Applicant: John T. Moy and Richard A. Barry
Serial No: 09/760,510
Filed: January 12, 2001
For: SERVICE DISCOVERY USING A USER DEVICE INTERFACE
TO AN OPTICAL TRANSPORT NETWORK

PRELIMINARY AMENDMENT

Fig. 4

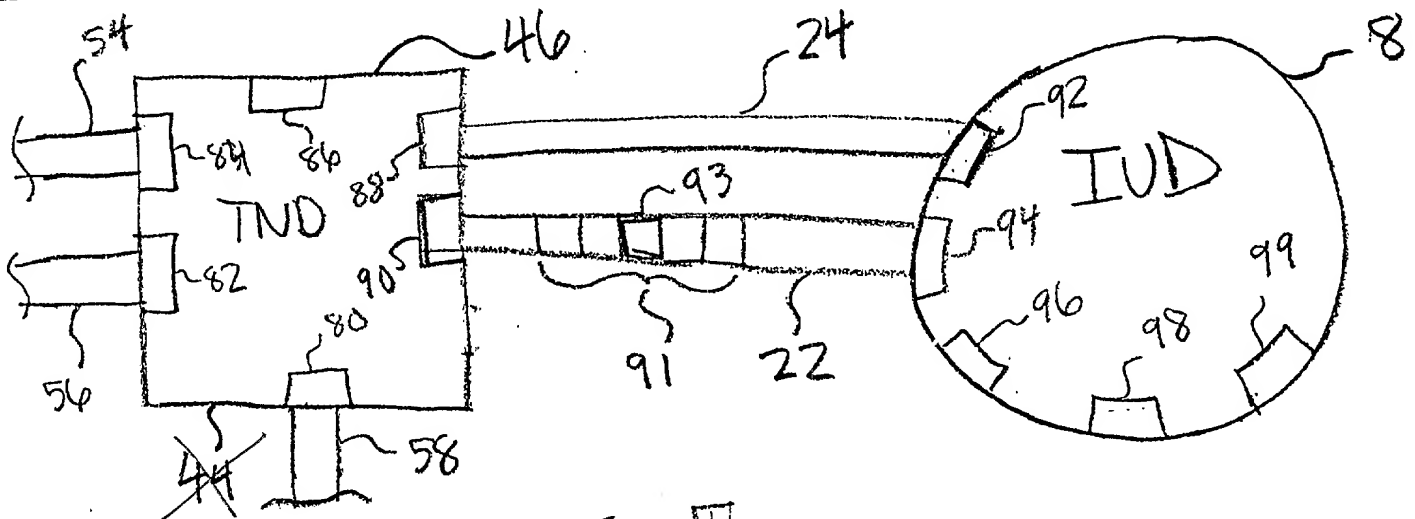
Fig. 4 is a block diagram illustrating an example embodiment of an optical trail that may be created across the OTN 4 of Fig. 1. This optical trail may include IUD 8, UDI link 22, TND 44, one or more internal links 51 and possibly one or more other TNDs of the OTN 4, [51,] TND 46, UDI link 35 and IUD 14.

Fig. 4 is a block diagram illustrating an example embodiment of an optical trail that may be created across the OTN 4 of Fig. 1. This optical trail may include IUD 8, UDI link 22, TND 44, one or more internal links 51 and possibly one or more other TNDs of the OTN 4, TND 46, UDI link 35 and IUD 14.
